Kilkenny County Council

Report – 12th December 2017

Abbey Quarter

Brewhouse Project

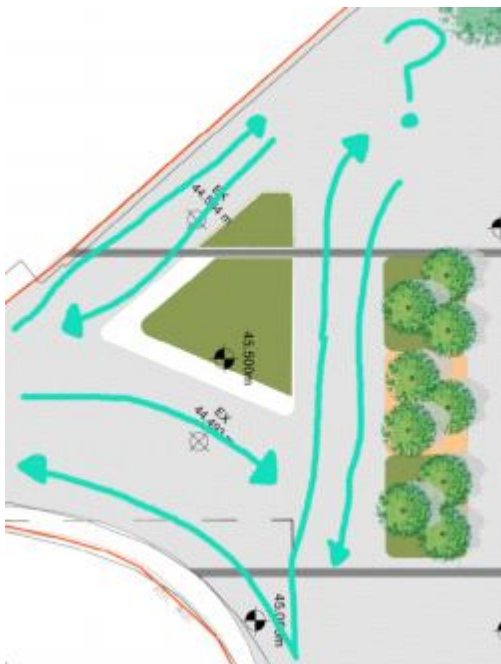
How are cyclists going to “flow” through the site? A particular example is the triangle in the plans, about where the guard station is today. Here is our sketch of ways cyclists might move through the site. But where do they go in the direction of the Abbey? There will be cycle access to the liner park, and hopefully St. Francis Bridge, so I am sure people will want to cycle through this area. Is there enough space around this triangle?

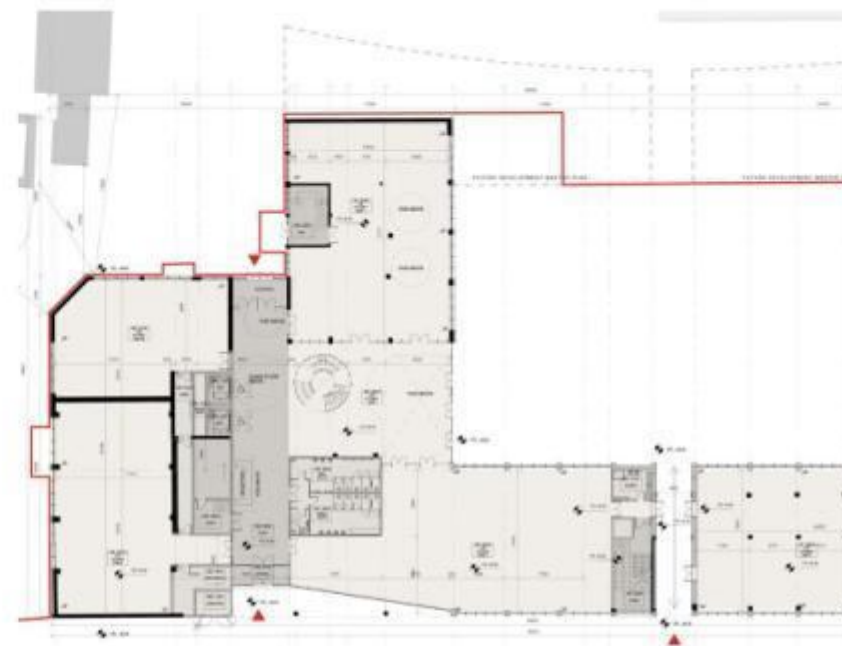
The proposed extension at roof level has been modified on the western or Horse Barrack Lane elevation to make the space more efficient and useable. The usability of this space was further improved by the relocation of the Sanitary Services core.

The proposed roof overhang of this element has been omitted following liaison with the planning and conservation departments. The removal of the overhang creates a glass extension that is light and unobtrusive. The glazed roof extension integrates into the building without imposing on it by its presence.

PROPOSED AMENDMENTS TO WEST ELEVATION

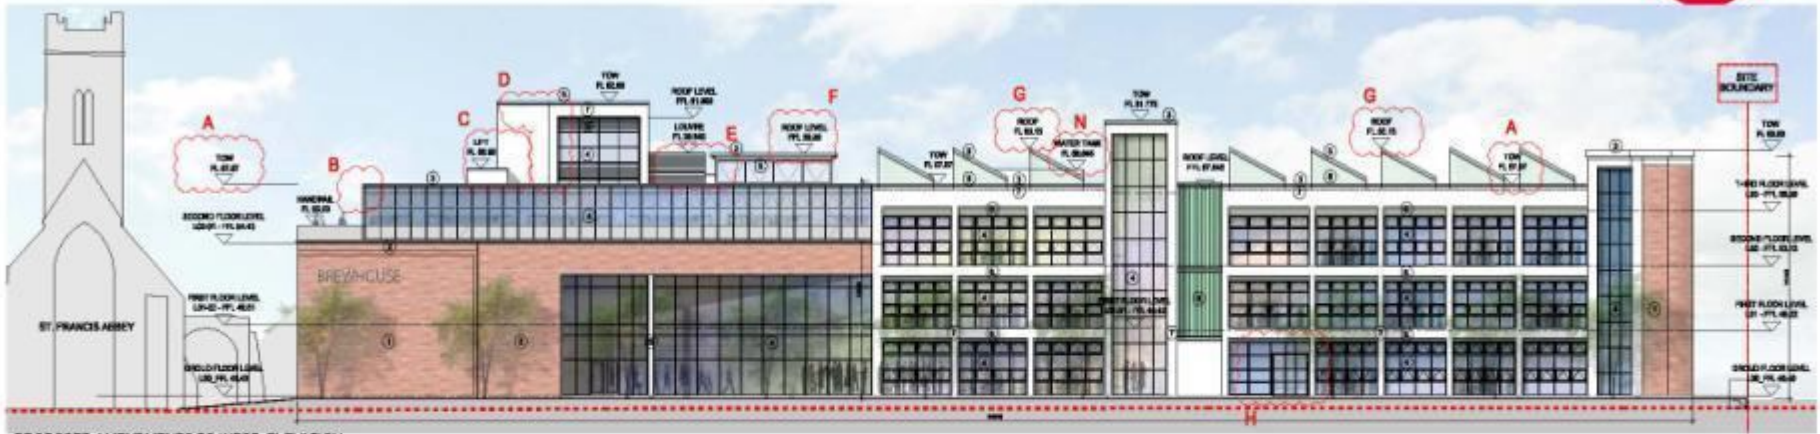
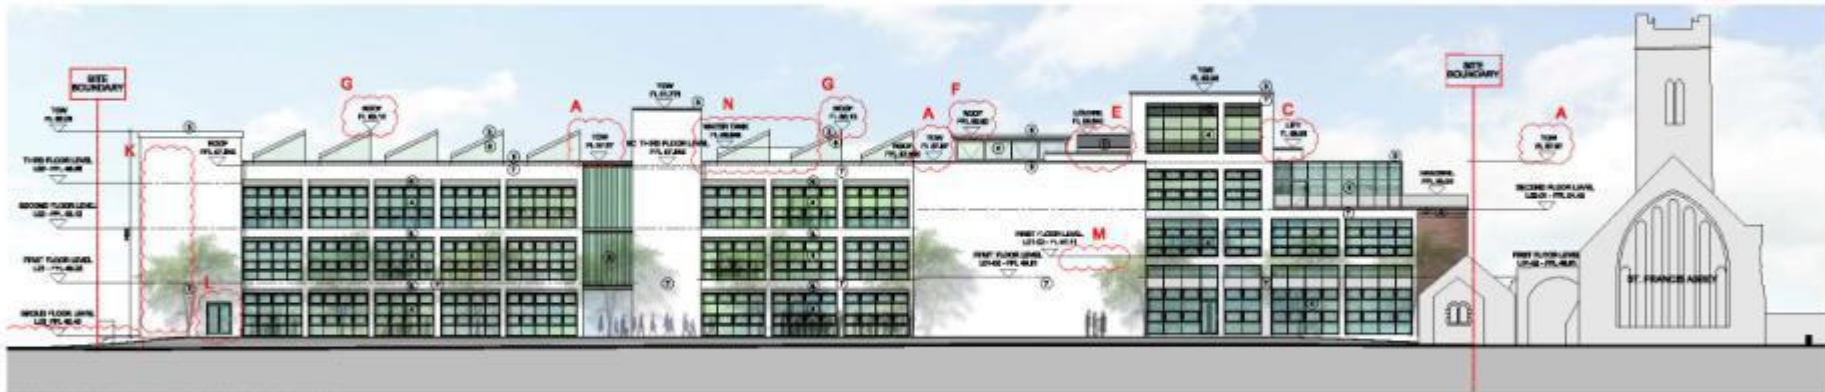
- A. Roof Heights and Levels Modified.
- B. Balcony Modified, Roof Overhang Omitted.
- C. Lift Moved to New Location.
- D. Existing 'L' profile of Plantroom Reinstalled.
- E. Platform to Accommodate Equipment, Screened with Metal Cladding.
- F. Roof Light Modified.
- G. Sawtooth Roof Modified.

- H. ESB Substation Relocated. Bay Recessed 1m into Facade.
- J. External Landscape Levels Modified.
- K. Window Removed.
- L. Door added.
- M. Existing Floor Retained. Floor Level Modified.
- N. Water Tank Screened Behind Sawtooth Roof Structure.
- P. Facade Updated to Reflect Existing Column Grid Structure.
- Q. Facade Updated to Reflect Internal WC Core Modifications.
- R. External Balcony Modified.
